Class II Permissive Change Letter

FCC ID: 2A6B4-F31TX

Subject: Request Class II Permissive Change for FCC ID: 2A6B4-F31TX

Memory chips before the change

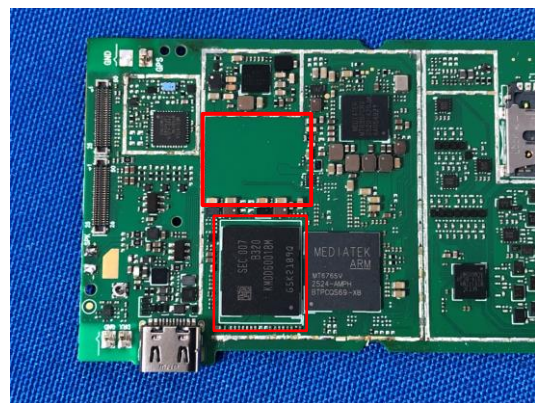
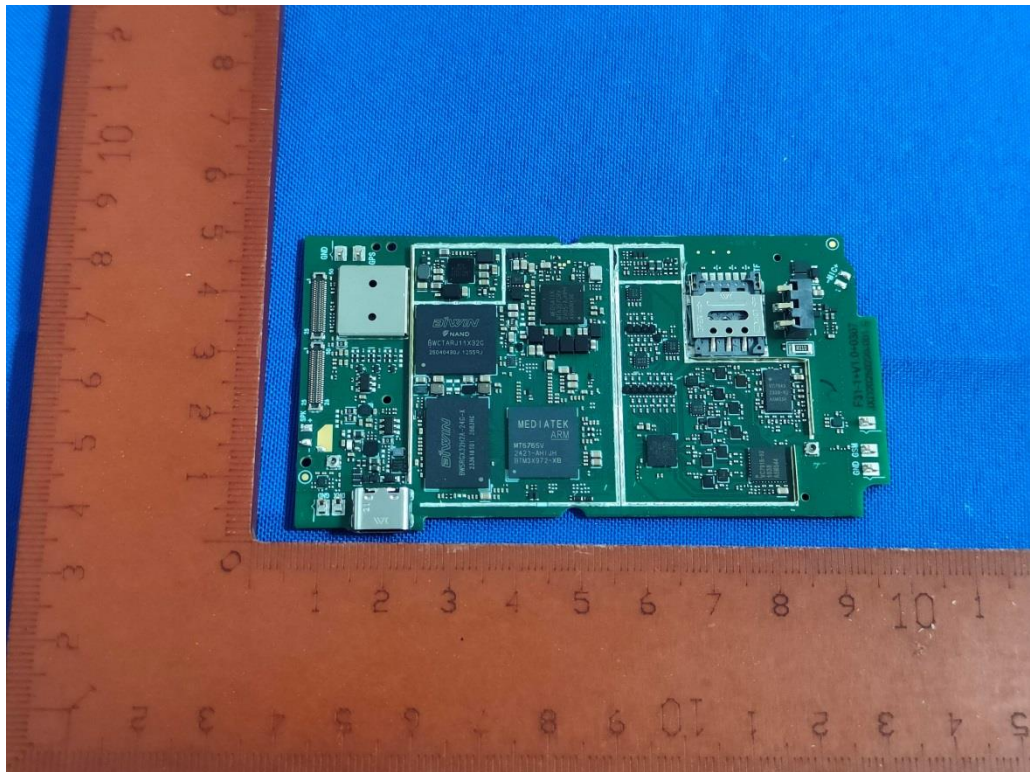
The only memory chip has changes

Memory chips after the change

Original
Top

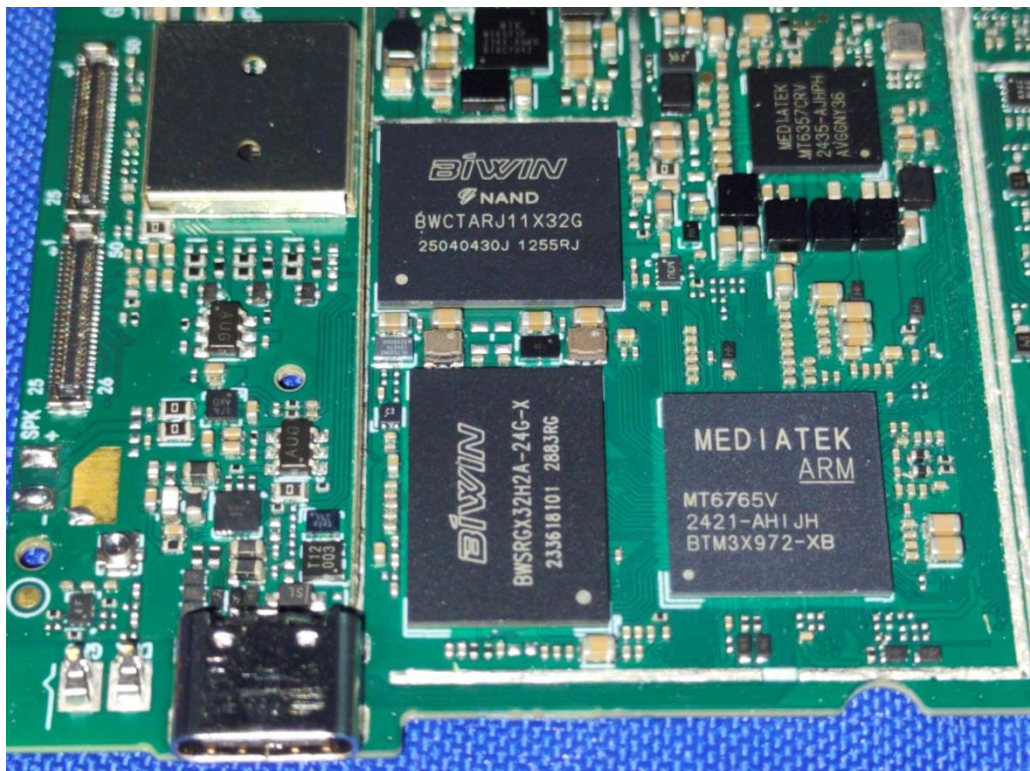
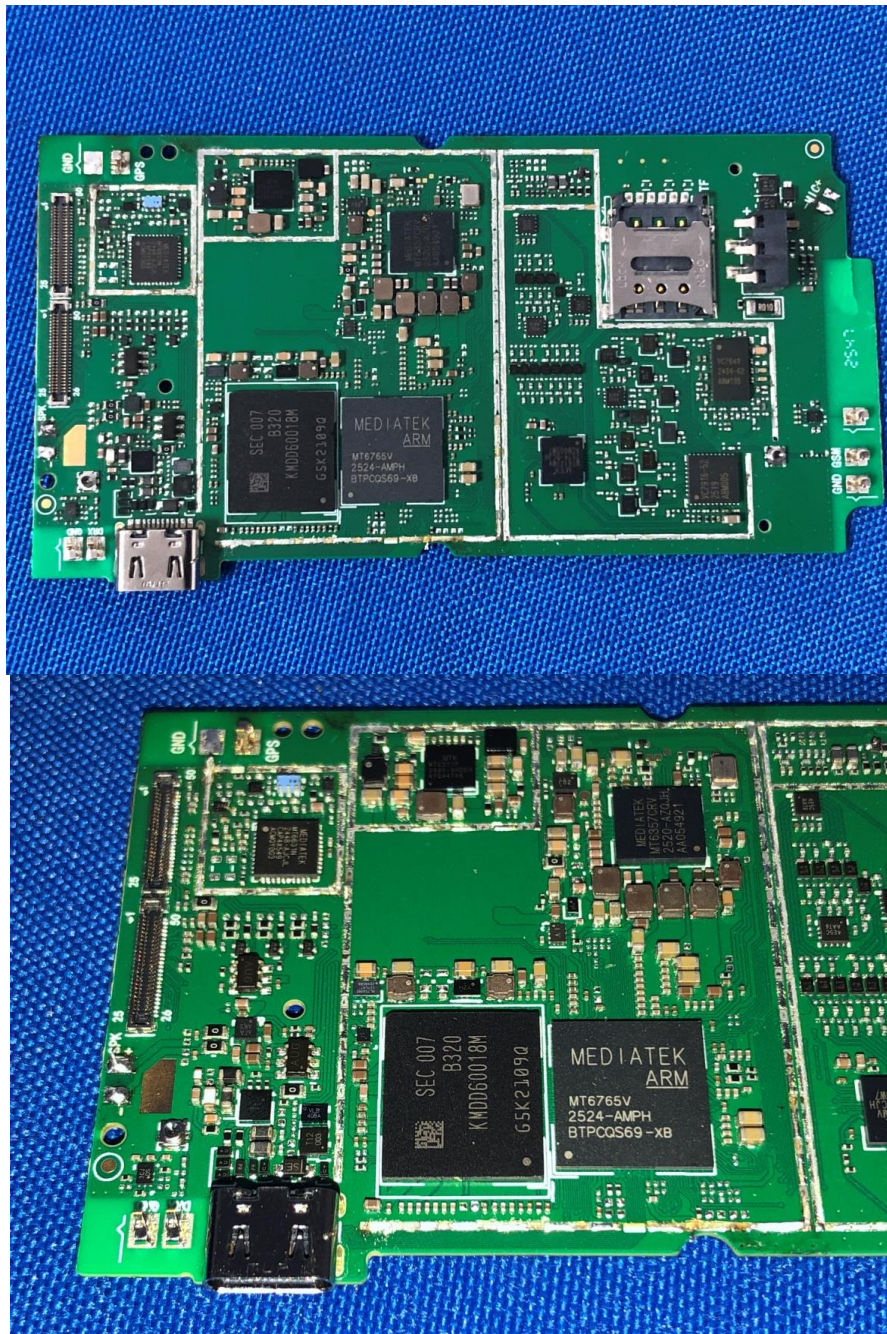
New
Top

I attest that such change will not affect BT/2.4GWIFI/5GWIFI/2G/3G/4G Radio section from antenna port (after pre-check, conducted power no higher than original for BT/2.4GWIFI/5GWIFI; Effective(Isotropic) Radiated Output Power no higher than original for 2G/3G/4G), only effect (AC Power line conducted emissions, Radiated Emissions and SAR section of BT/WIFI) and (Effective(Isotropic) Radiated Output Power, Field Strength of Spurious Radiation and SAR of 2G/3G/4G).
